ADDENDUM NO. 24

**Westfield Washington School Corporation
Bid Package 06, Bid Item #33
SR32 & Centennial Road New Roundabout Construction
17707 Centennial Road,
Westfield, IN. 46074**

ADDENDUM NO. 24

RE: Westfield Middle School – West

PLAN - LINE "PR-E"
STA. 70+00.00 TO STA. 76+00.00

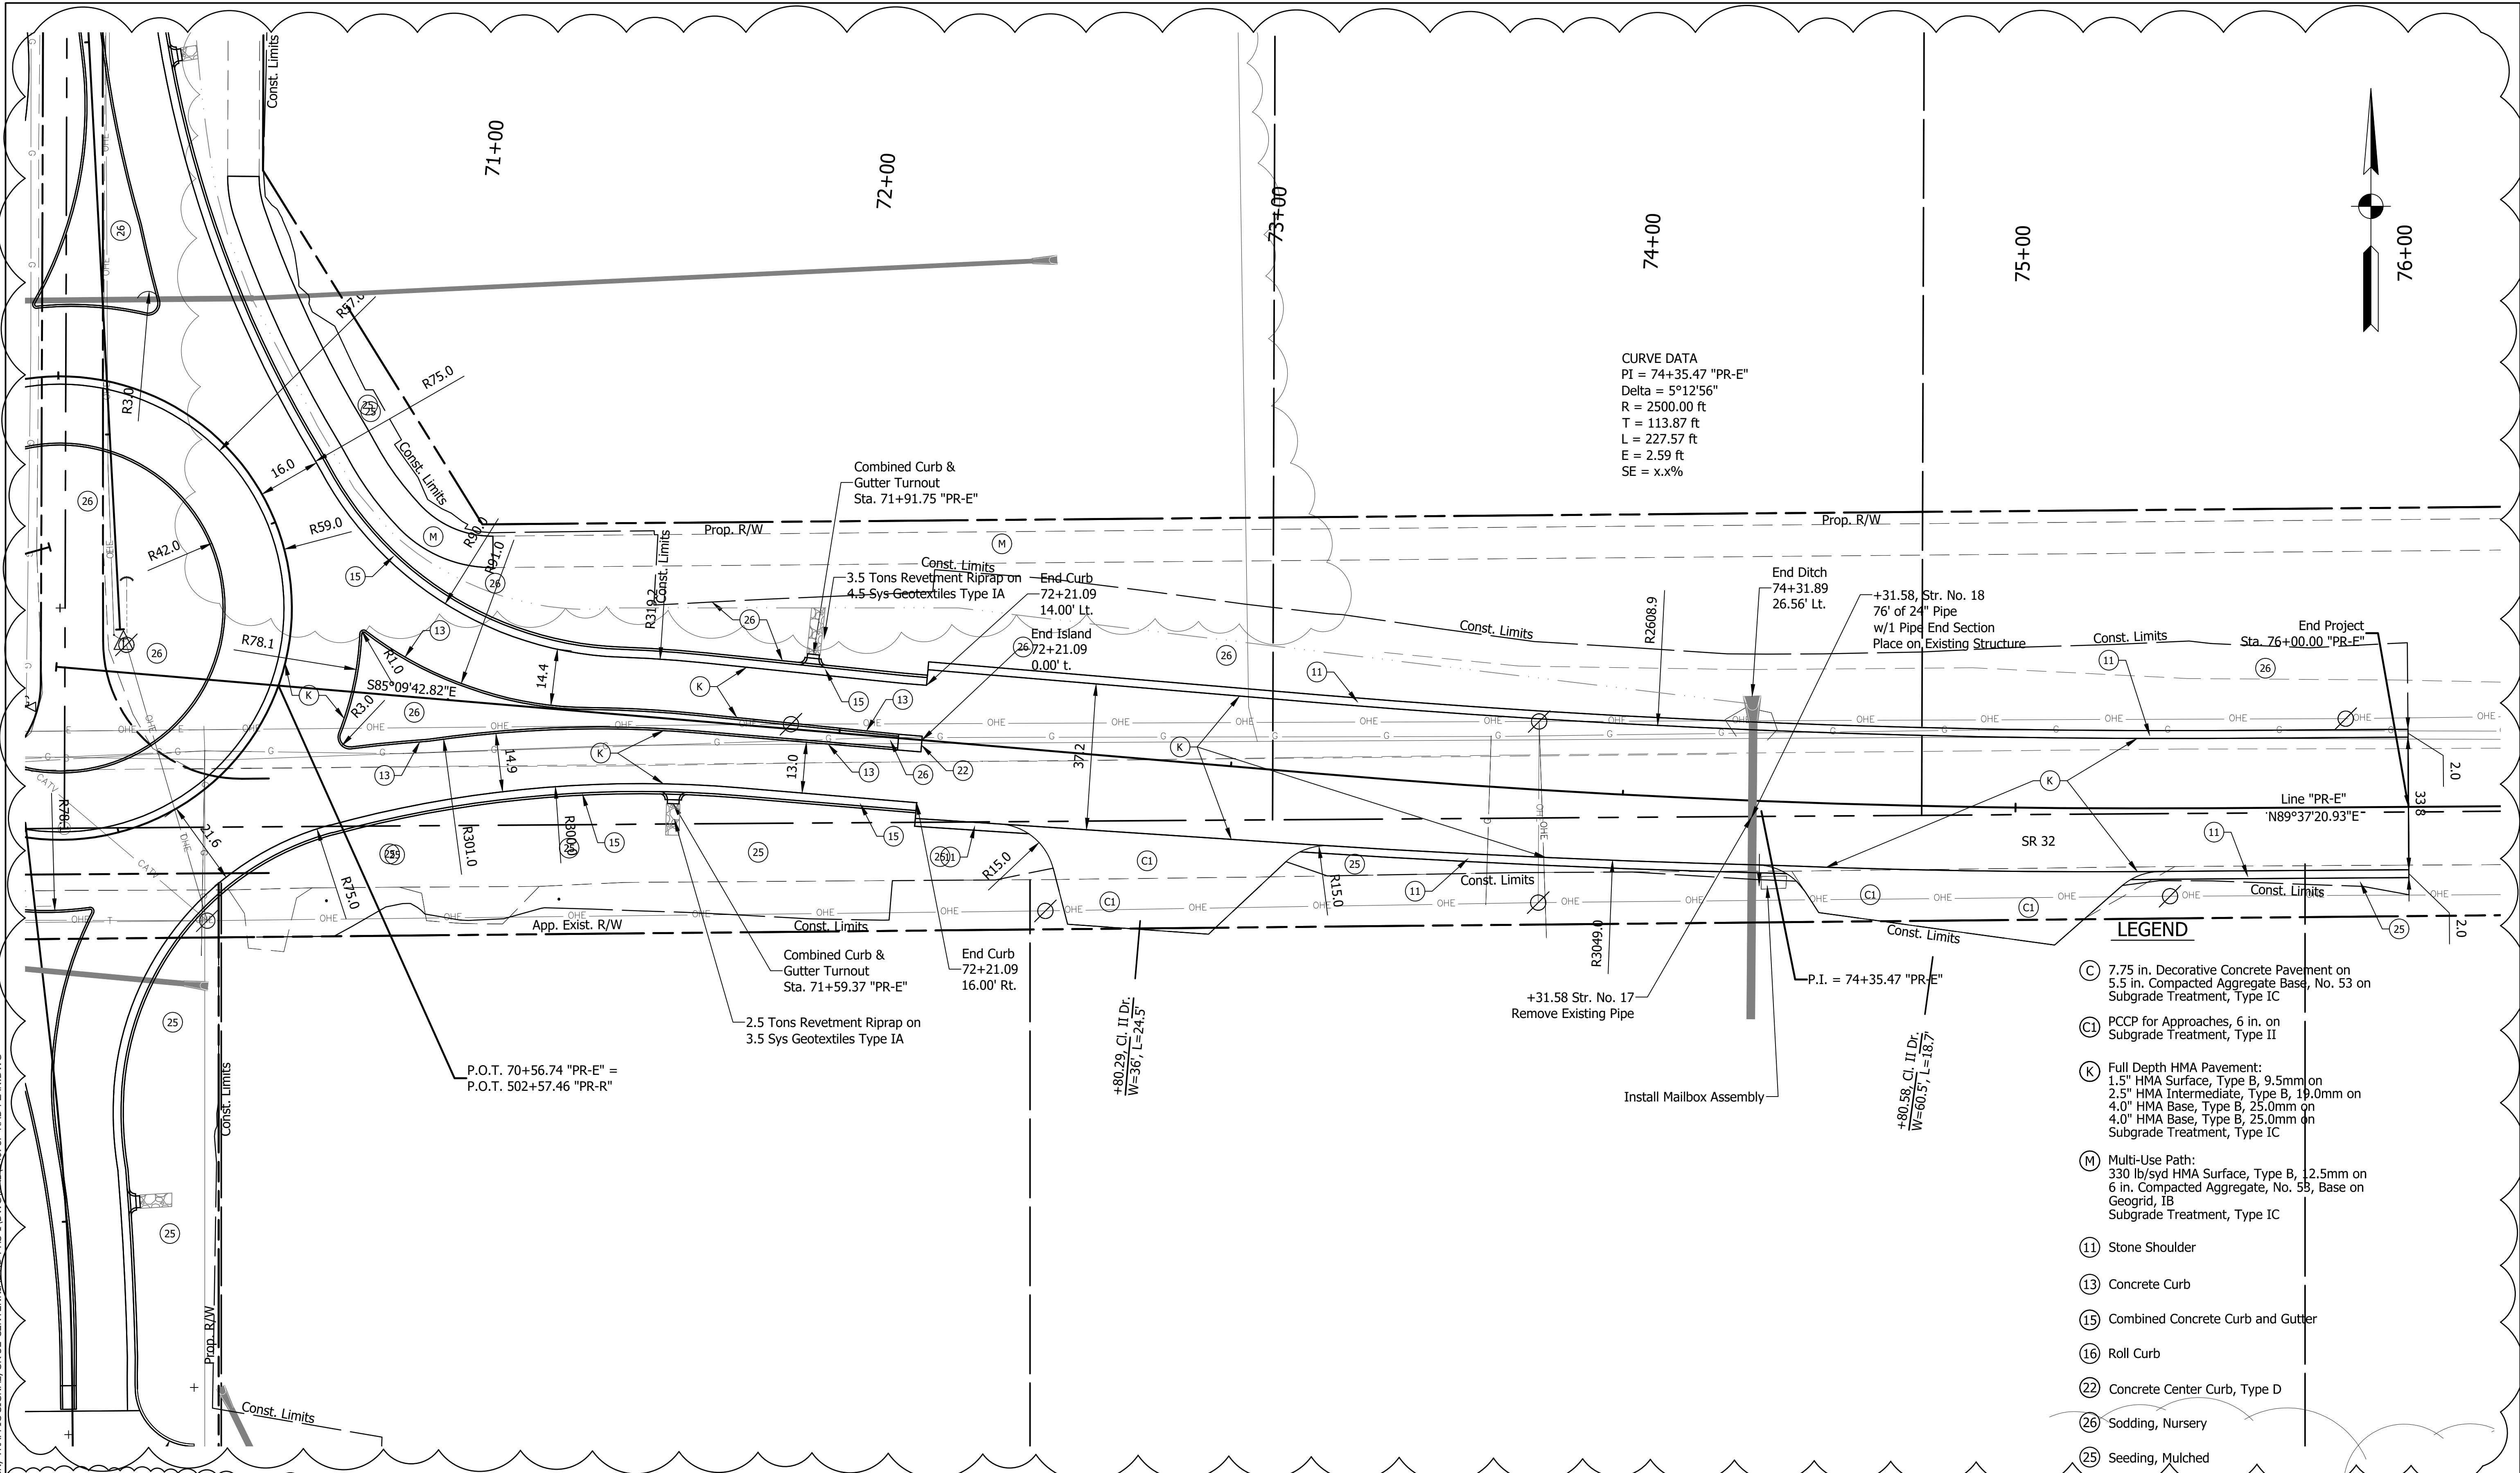
REVISIONS	
ITEM	
09-28-2026	Added Construction Limits, Seeding Locations, Earthwork Summary Table, Changed Subgrades

A. Sodding and seeding callouts in the plans have been modified and updated for clarification. Sod is required in the central island and in the corner between curb and multi-use trail, and mulched urban seeding is used in the other disturbed project areas.

PLAN - LINE "PR-S"
STA. 77+00.00 TO STA. 83+00.00

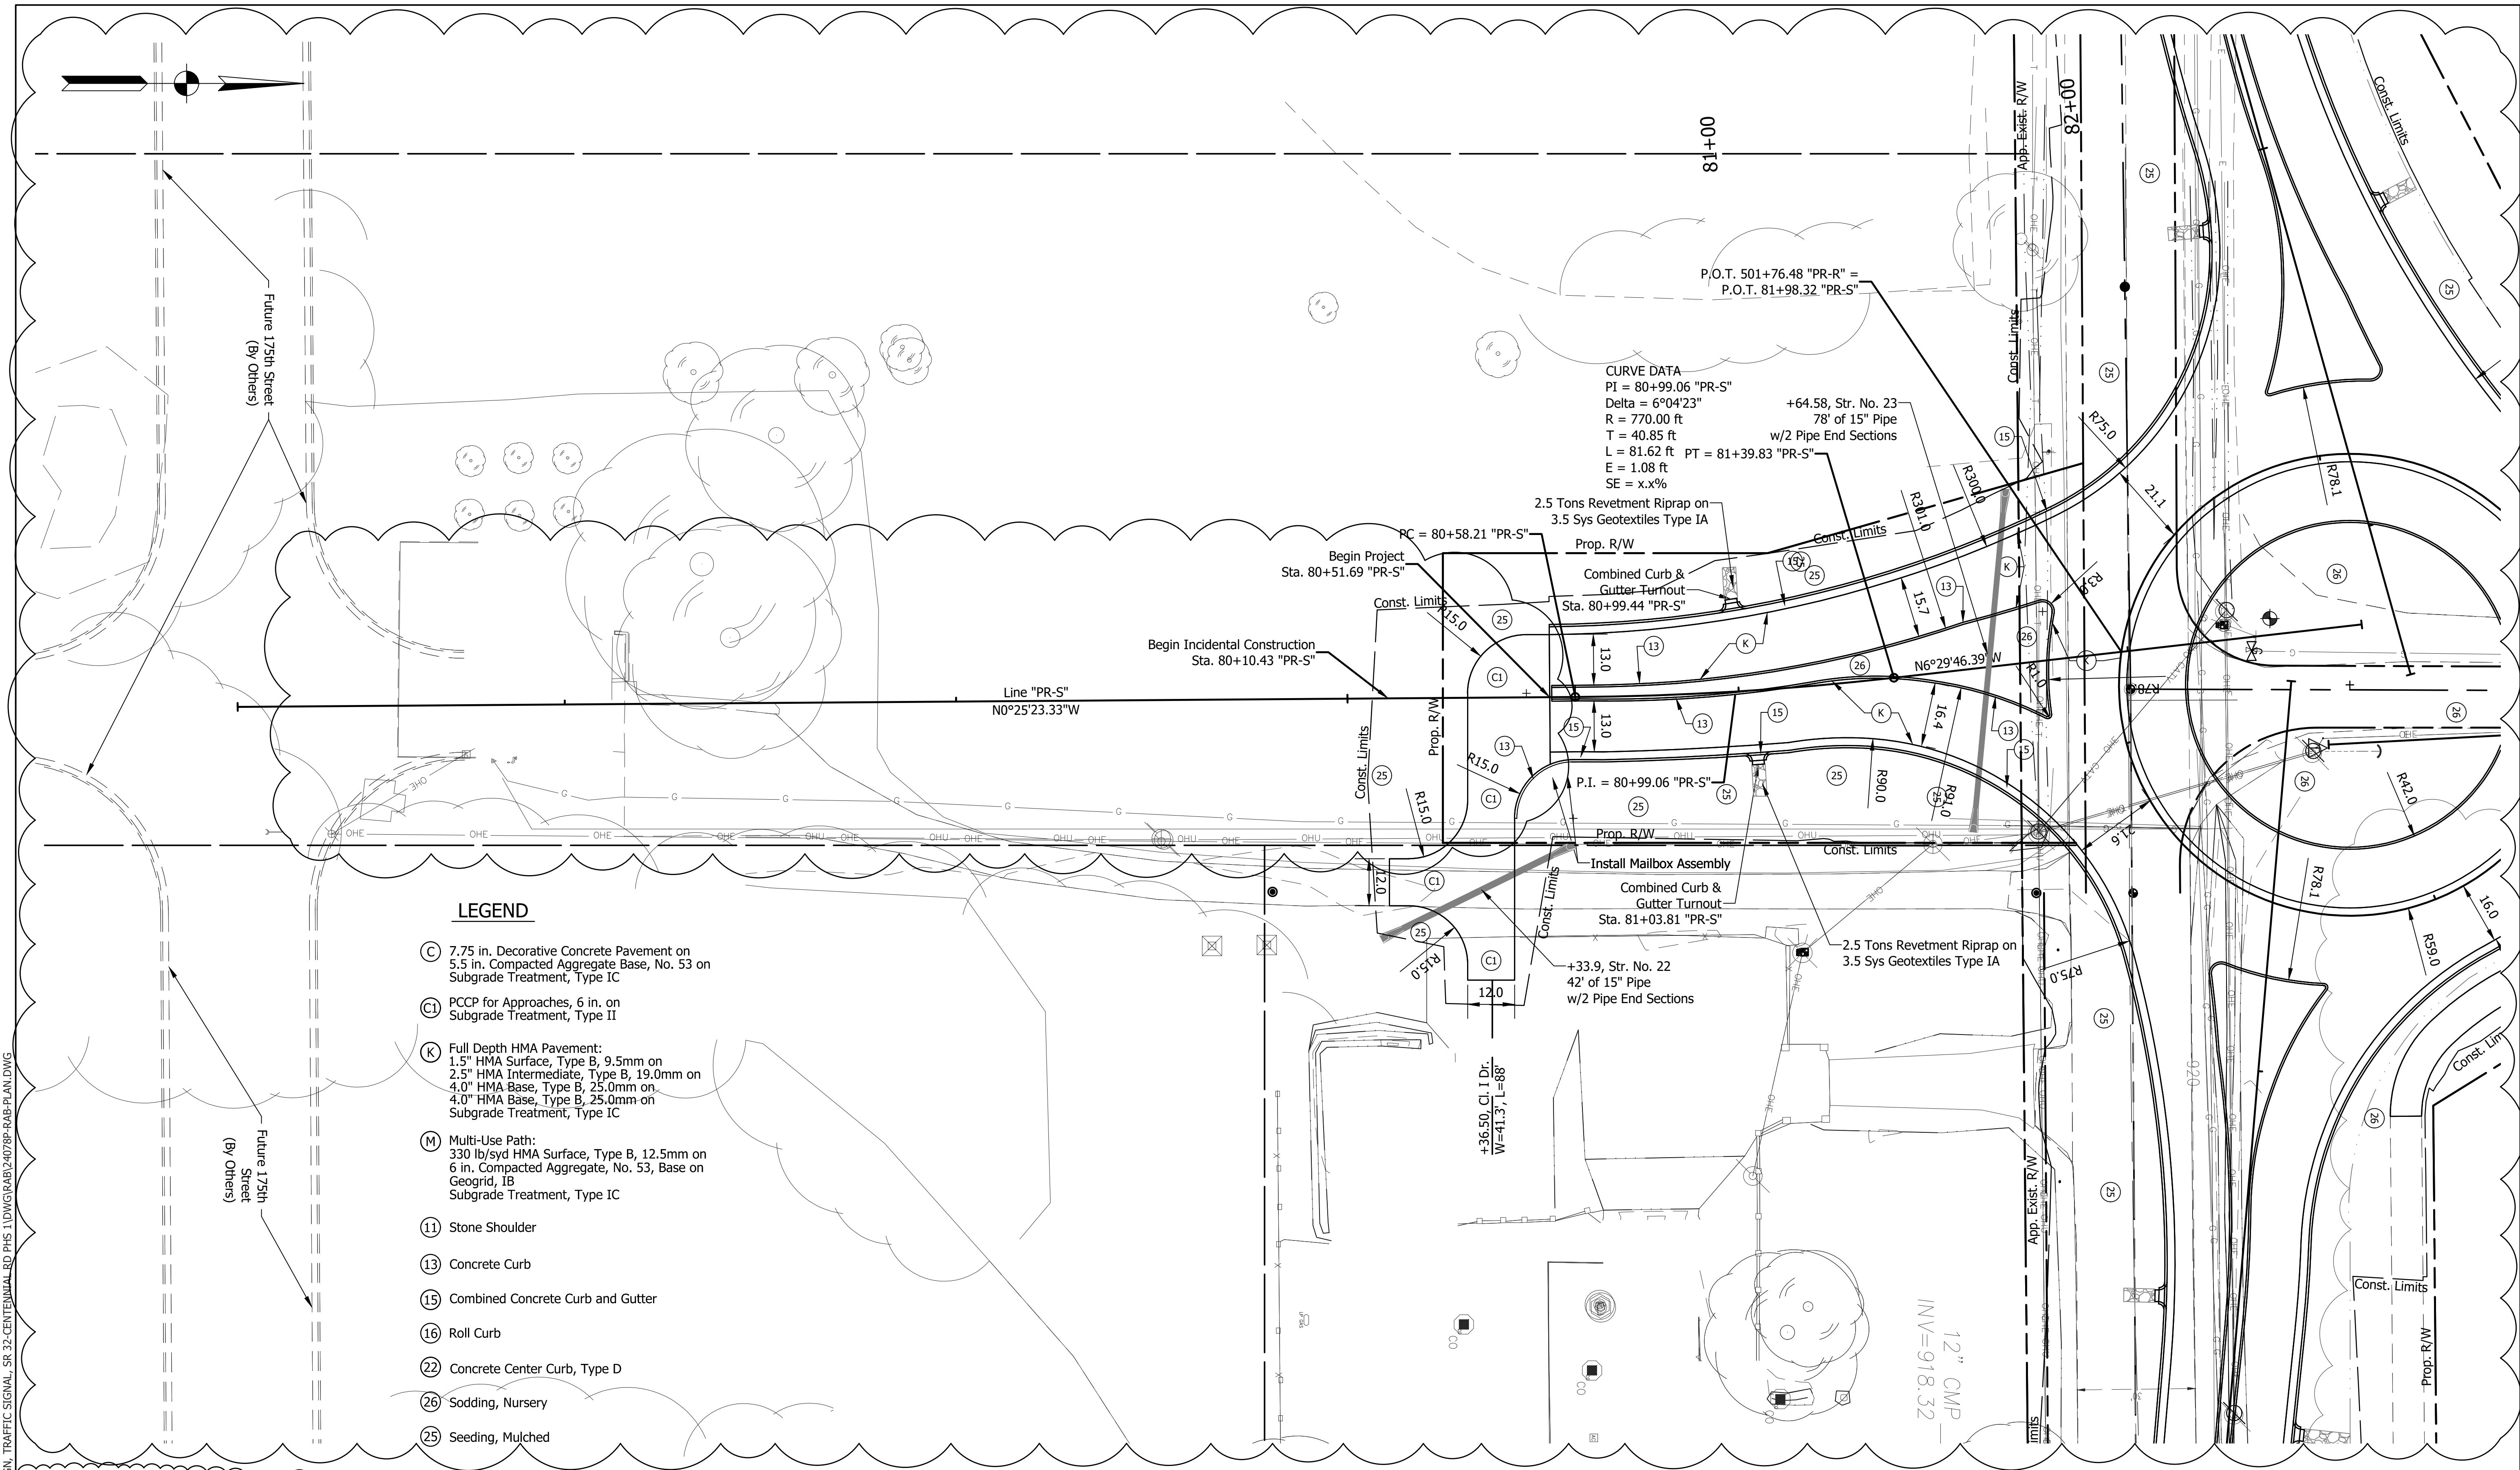
REVISIONS	
DATE	ITEM
09-17-2026	Adjusted South Leg to shorten project.
09-28-2026	Added Construction Limits, Seeding Locations, Earthwork Summary Table, Changed Subgrades

- A. The south leg of the intersection now stops short of the home(s) and demolition is not anticipated to be part of this contract.
